As-Built Baseline Monitoring Report

APPLE VALLEY PROJECT

NCDMS Project #100063 (Contract #7531)

RE: Apple Valley Site: Baseline Report and As-Built Drawings (NCDMS ID 100063)

SHEET NUMBER:
P1

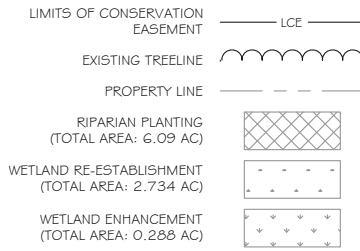
Please rename "Apple Valley Redlines" to the appropriate deliverable name. If this is intended to be the project record drawings, please make sure the title reflects that. Please include the planting plan as part of the record drawings. Any deviations in any of the sheets from mitigation plan to as built conditions need to be shown in red and discussed in the report.

[The title has been revised and the planting plan was added to the record drawings.](#)
